**ALLEGHENY COUNTY SANITARY AUTHORITY**

**CONTRACT NO. 1735 G, E, H, P**

**ALCOSAN PARKING GARAGE**

**ADDENDUM NO. 2**

2 SECTION THRU WEST BAY LOOKING WEST  
 A-30 SCALE: 3/32" = 1'-0"

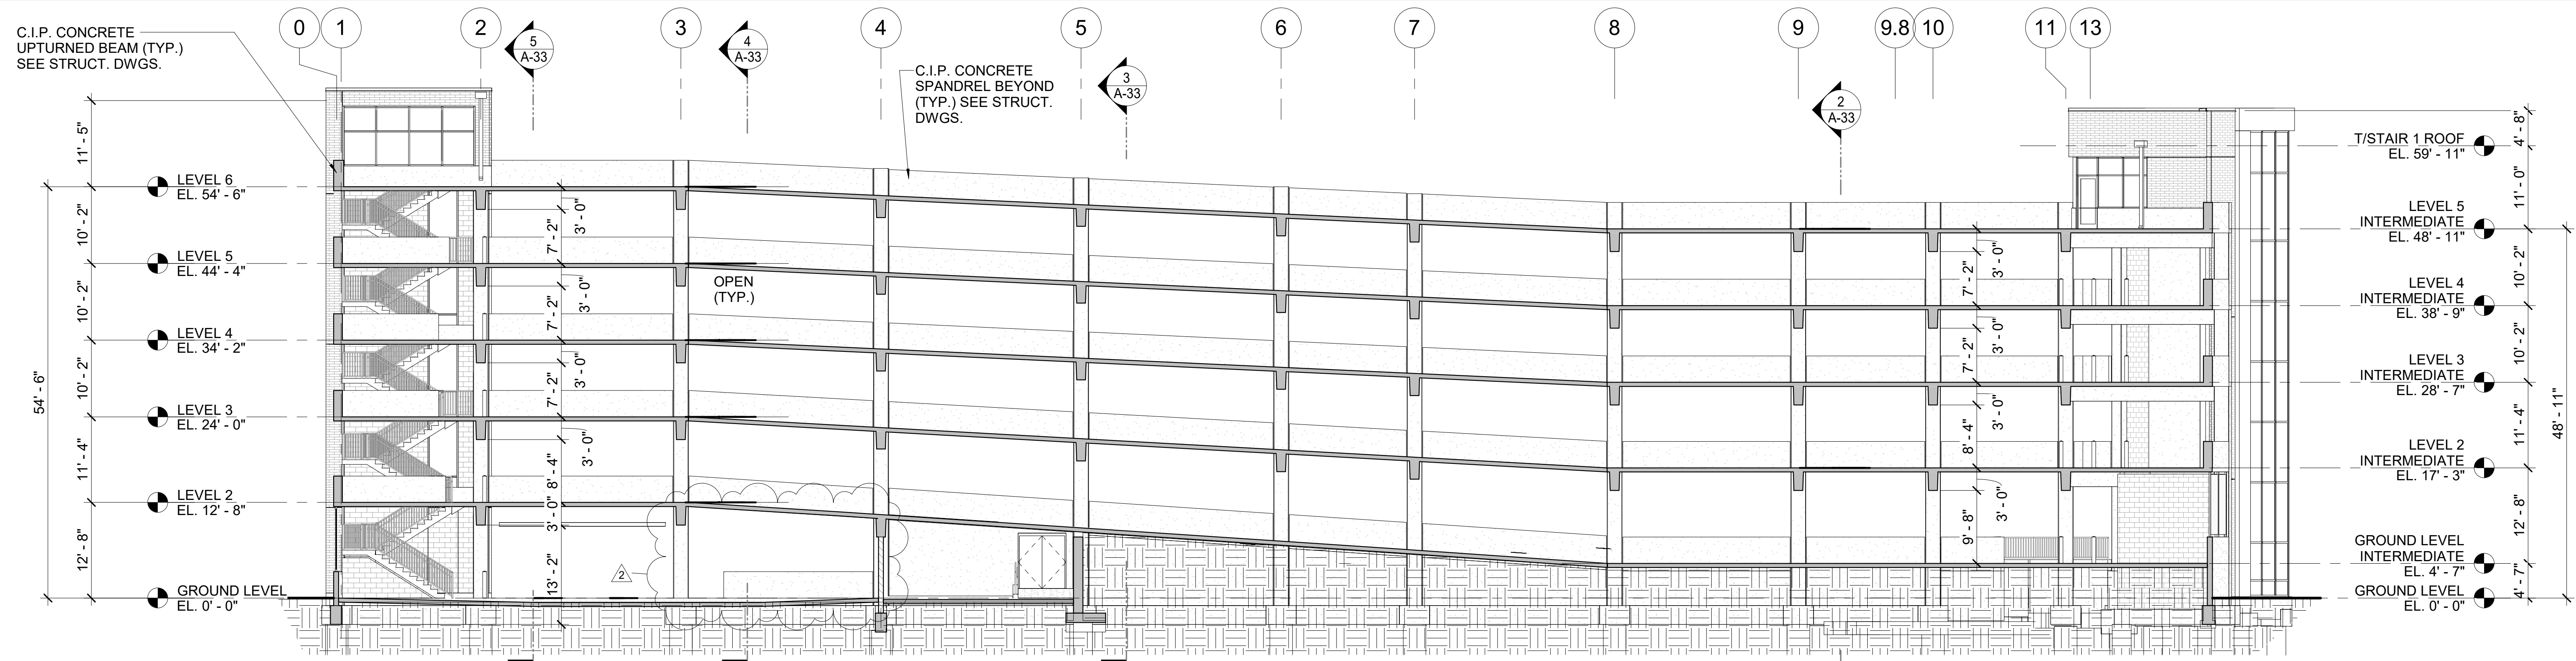
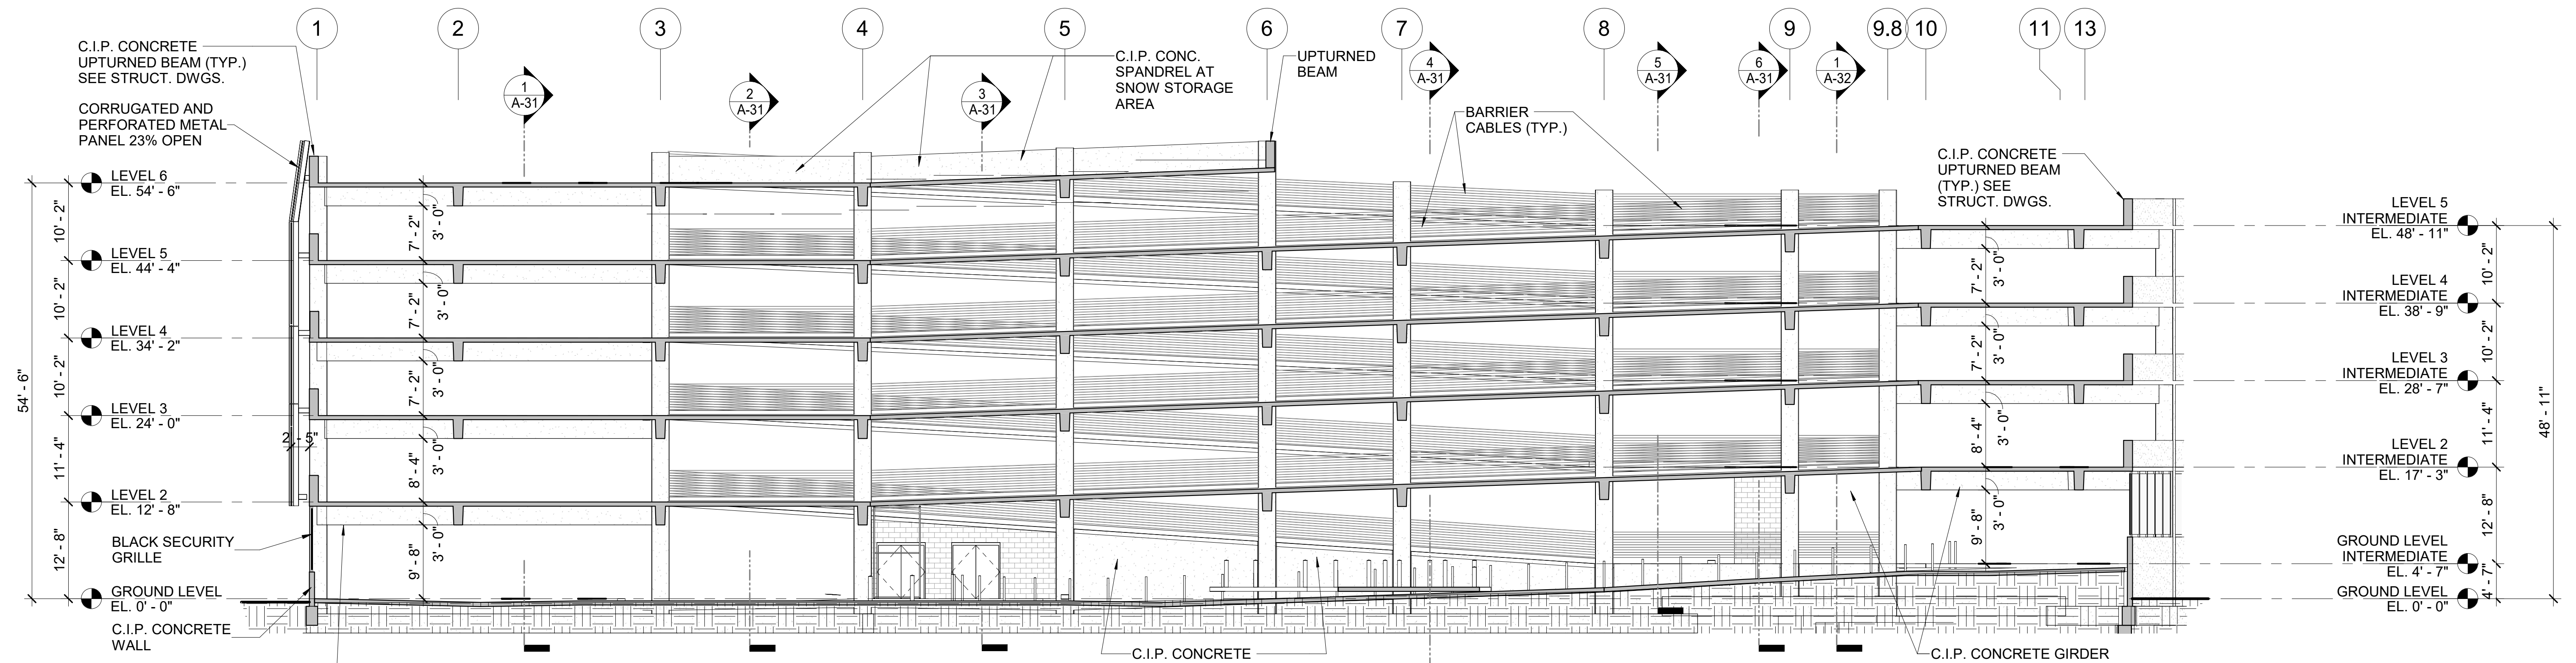
- a. REPLACE with the attached drawing 210-A-30.
  - b. In section 2, security grille and door are deleted between gridlines 3 and 4.

**1 STAIR 1/ELEVATOR - LEVEL 3 PLAN**  
 A-42 SCALE: 1/4" = 1'-0"

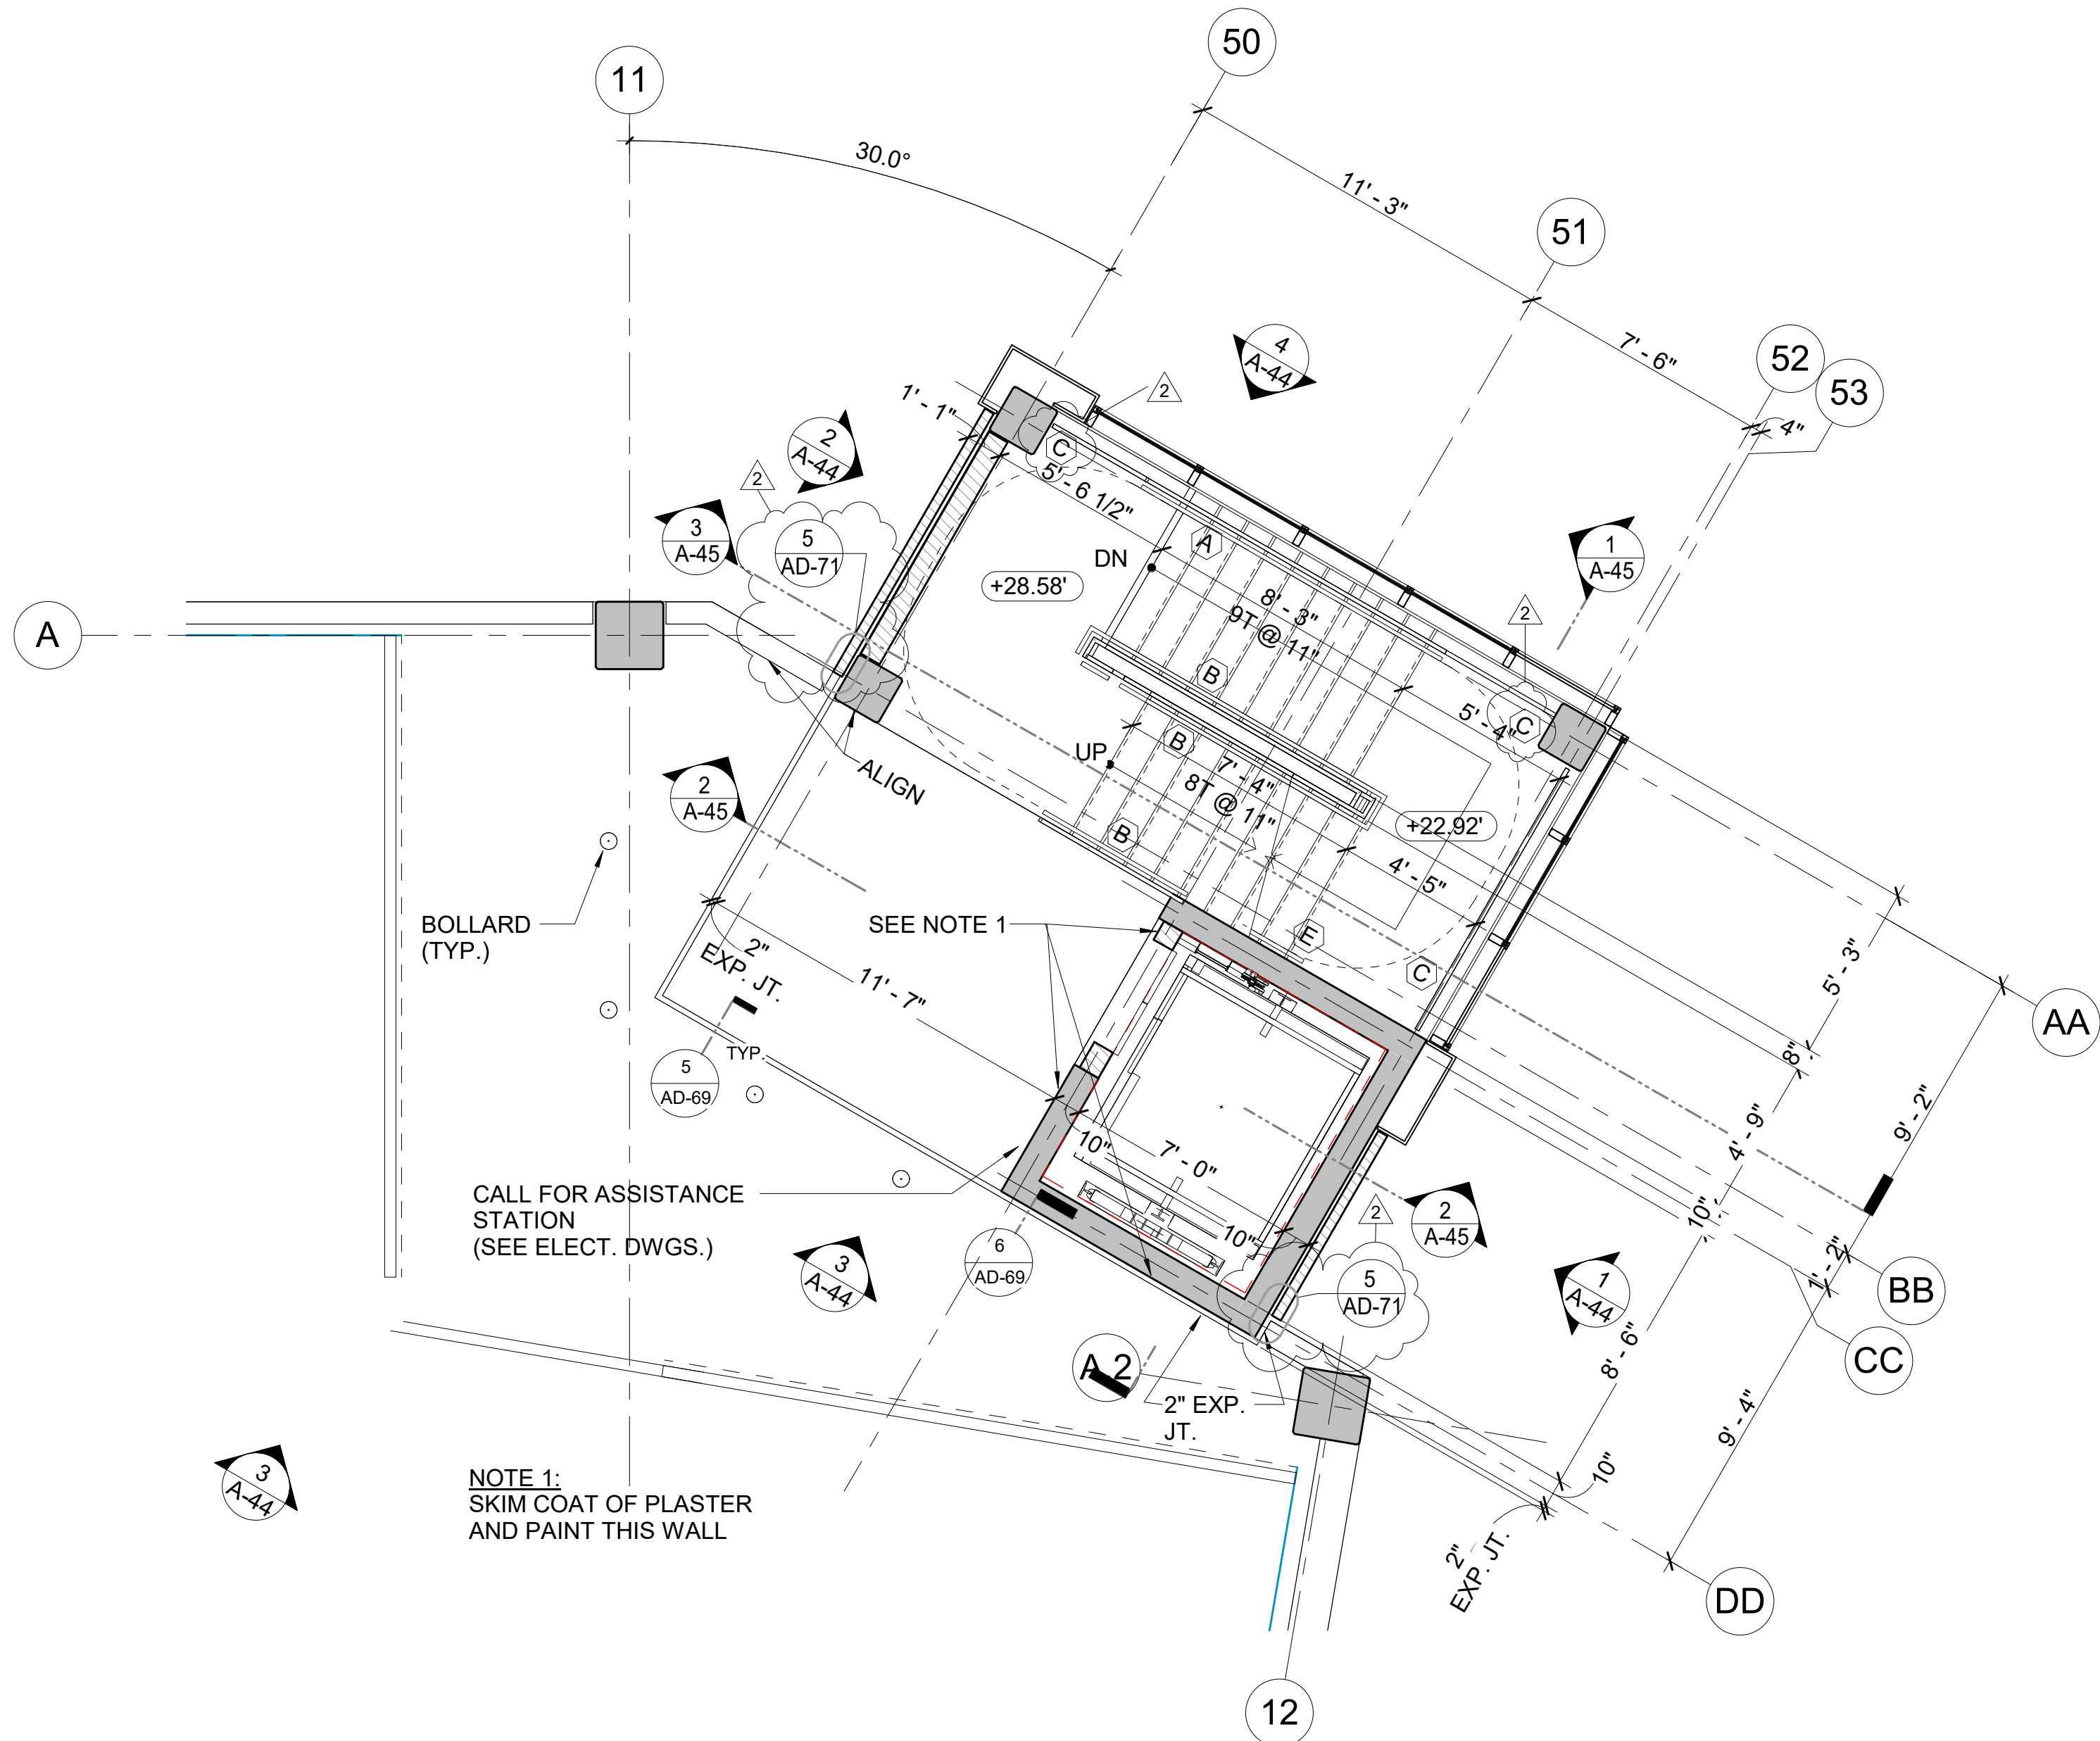
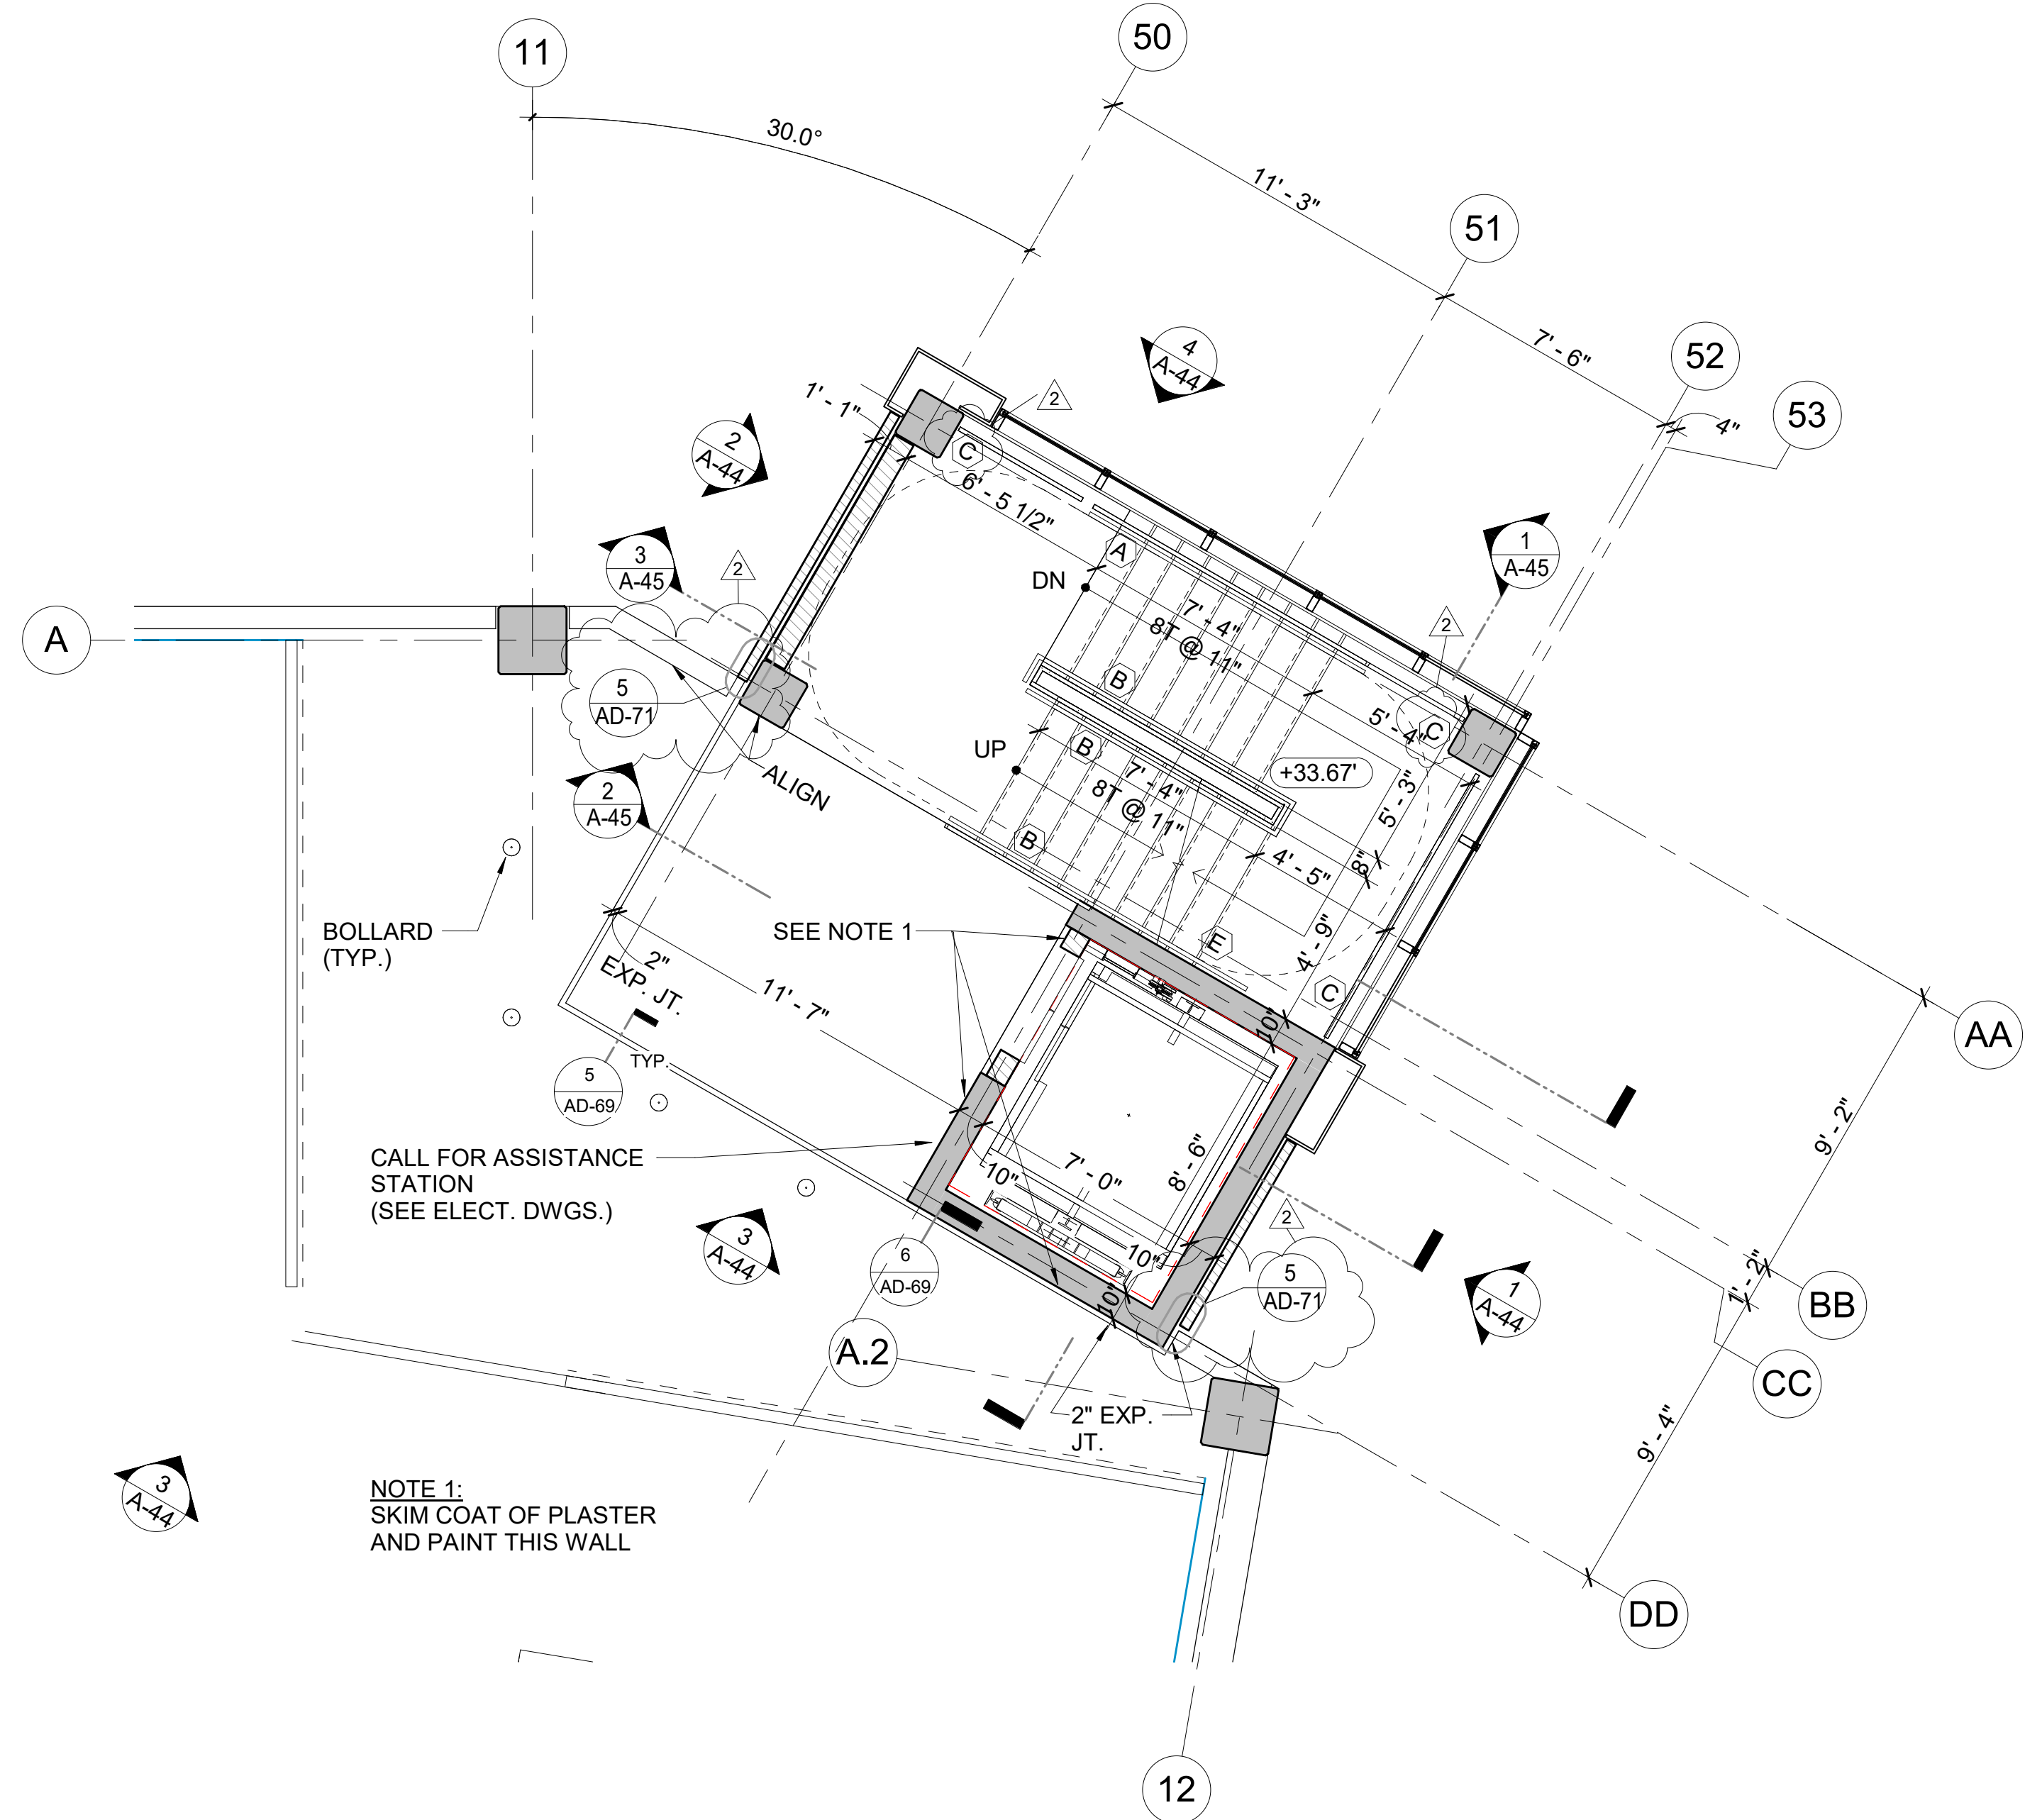
19. Drawing 210-A-42 - STAIR 1 / Elevator - Enlarged 3<sup>rd</sup> and 4<sup>th</sup> Level Plans
  - a. REPLACE with the attached drawing 210-A-42.
  - b. In plans 1 and 2, railing keynote C is added.
  - c. In plans 1 and 2, references to 5/210-AD-71 are added.
